ISO
11439

AMENDMENT 1
2021-10

Gas cylinders — High pressure cylinders for the on-board storage of natural gas as a fuel for automotive vehicles

Reference number
ISO 11439:2013/Amd.1:2021(E)

Figure H.1 — Accelerated cyclic corrosion flow diagram

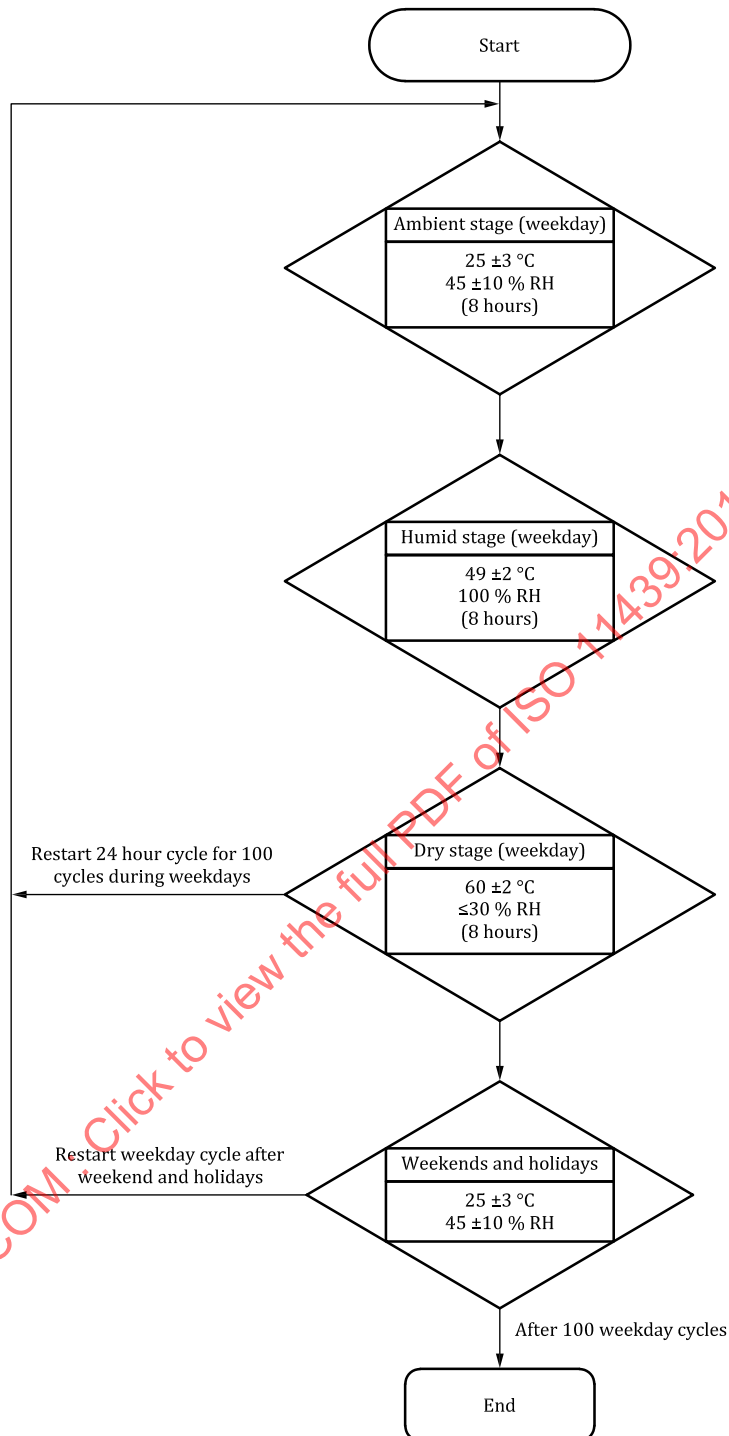
Add a new annex at the end of Annex G as follows:

The test method involves 1 % (approximate) complex salt mist applications coupled with high temperature, high humidity and high temperature dry off. One test cycle is equal to 24 h, as illustrated in Figure H.1.
